<b>Well Name:</b> APACHE FEDERAL	<b>Well Location:</b> T24N / R5W / SEC 18 / NWSE / 36.311367 / -107.400719	<b>County or Parish/State:</b> RIO ARRIBA / NM
<b>Well Number:</b> 10	<b>Type of Well:</b> CONVENTIONAL GAS WELL	<b>Allottee or Tribe Name:</b> JICARILLA APACHE
<b>Lease Number:</b> JIC69	<b>Unit or CA Name:</b>	<b>Unit or CA Number:</b>
<b>US Well Number:</b> 3003905477	<b>Well Status:</b> Producing Gas Well	<b>Operator:</b> HILCORP ENERGY COMPANY

**Sundry ID:** 2728582

**Type of Action:** Plug and Abandonment

**HILCORP ENERGY COMPANY**  
**Apache Fed #10**  
**NOTICE OF INTENT TO PERMANENTLY ABANDON**

**Apache Fed #10 - PROPOSED P&A SCHEMATIC**

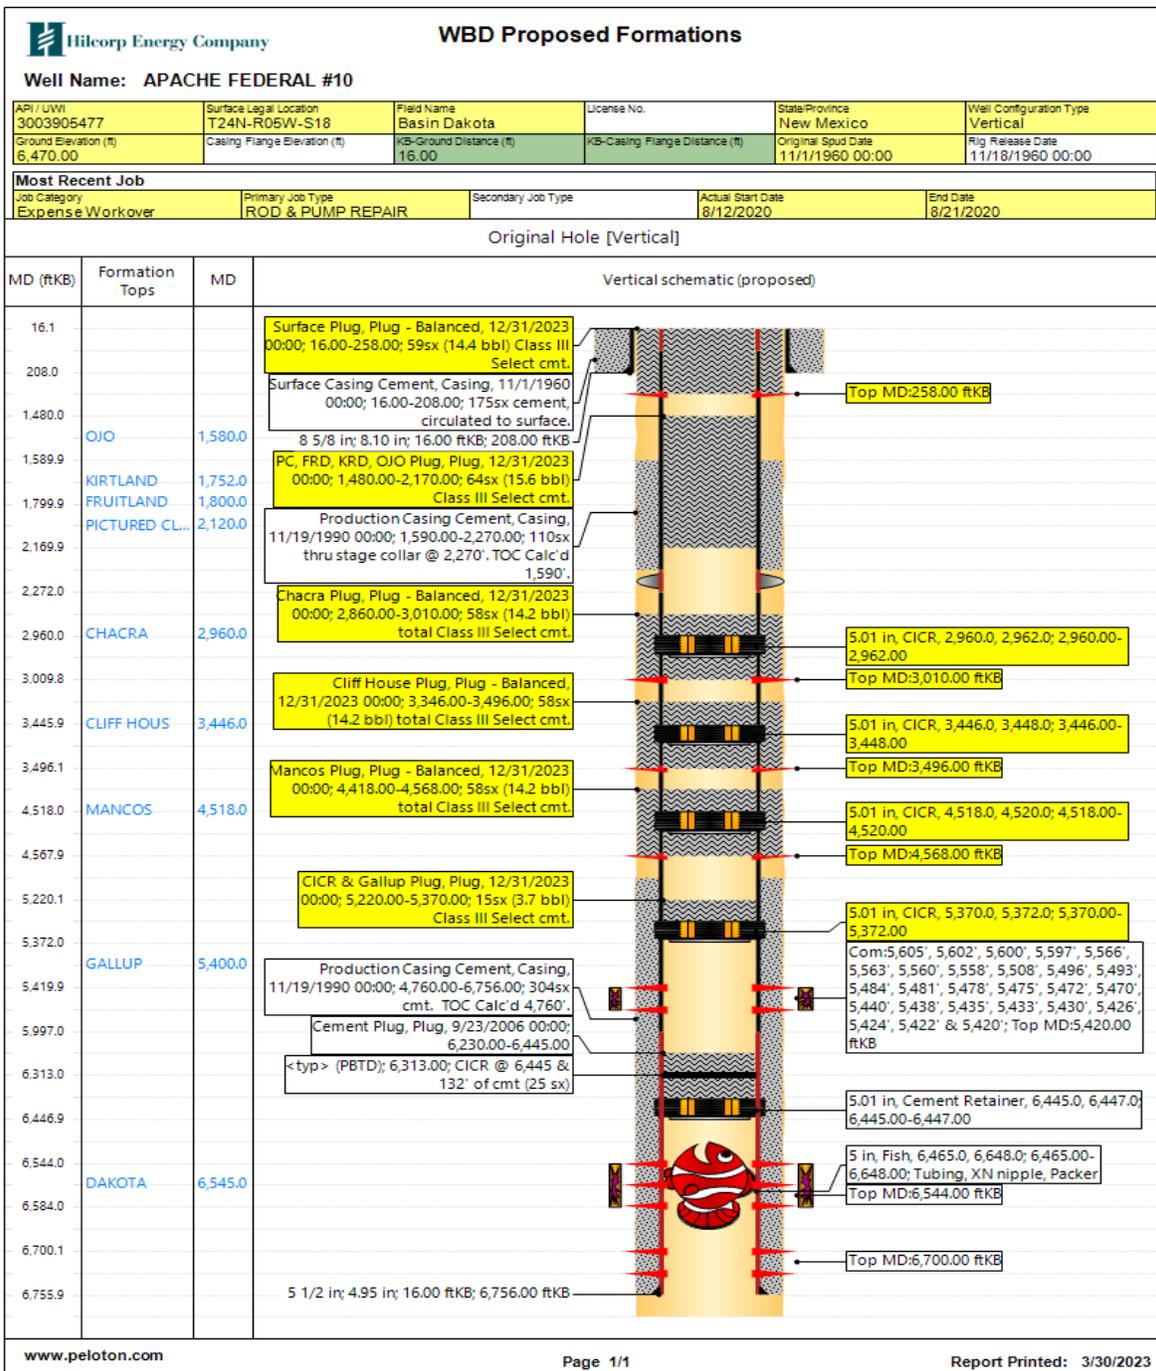
- Sundry ID: 2728582
- BLM picks for the Fruitland, Cliff House, Menefee and Dakota vary from operator.
- Adjust Plug #3 (Cliff House), or add a plug, to cover BLM formation top pick at 3644'.
- Gallup perfs 5420' – 5605'.

1. Plugging operations authorized are subject to the attached "General Requirements for Permanent Abandonment of Wells on Federal and Indian Lease."
2. The following modifications to your plugging program are to be made:
  - a. Adjust Plug #3 (Cliff House), or add a plug, to cover BLM formation top pick at 3644'.
3. Farmington Office is to be notified at least 24 hours before the plugging operations commence at (505) 564-7750.
